ZONING ADMINISTRATOR MEETING AGENDA

PUBLIC HEARING**2. SC24-0006 – Narinder Paul – 1501 Oakley Drive**

SUBMITTAL OF PLANNING APPROVAL FOR
PAUL RESIDENCE
1501 OAKLEY DRIVE
LOS ALTOS, CA 94024
APN:318-10-025

A-4.0

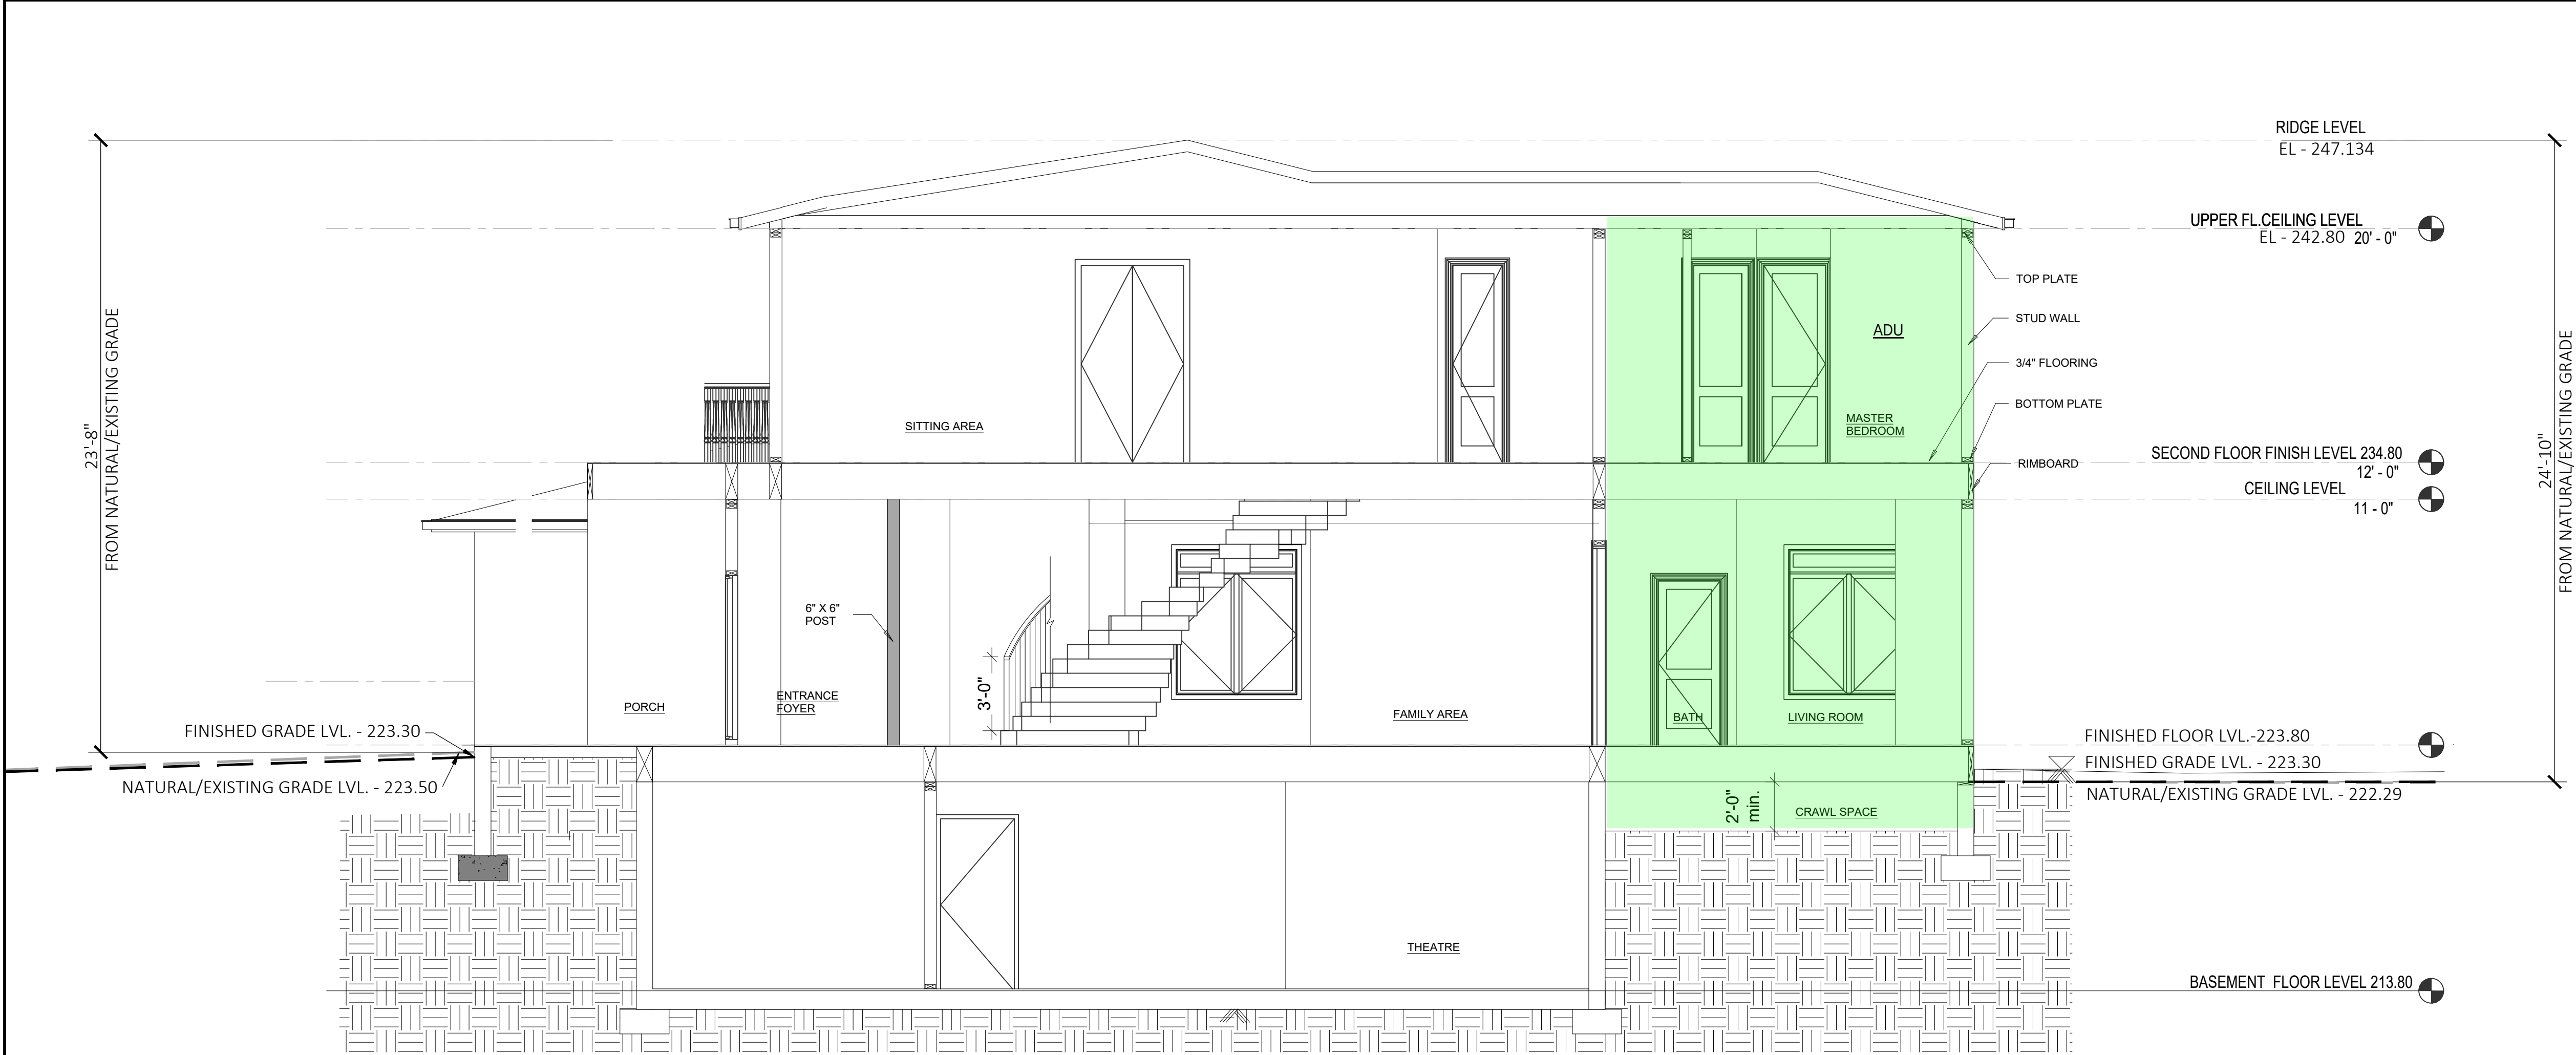
When viewing the provided rendering, one sees that the balcony adjacent roof areas are left hollow and unresolved. The building section A (sheet A-4.0), although incomplete, is drawn to prevent understanding of the sloping roof at the balcony as if it does not exist. The entry gable thickness and height are incorrectly drawn, as if to align with the second-floor framing, which according to the elevation, they would not. The roof plan (sheet A-2.2) indicates that the sloped roof extends fully to the second-floor walls. It is impossible to decipher which of these varying illustrations depicts the actual intended result. One is left to wonder whether this detailing has been considered at all. Studying the second-floor balcony interactions with the roof only leads to confusion. In these situations, unintended results are all too frequent in construction. This is a prominent street facing element of the house, and correctly illustrating these interactions needs to be a part of a complete design presentation. The front elevation indicates that the garage roof and the front roof do not engage, while the roof plan shows them meeting at the gutter. The front elevation indicates that the entry gable does not engage with the same front roof, while the roof plan indicates the opposite. (see fig. B). Without resolution of these intersections, it is impossible to tell what the front of the home will actually look like. This lack of clarity is further confused by the complete ambiguity of the front balcony.
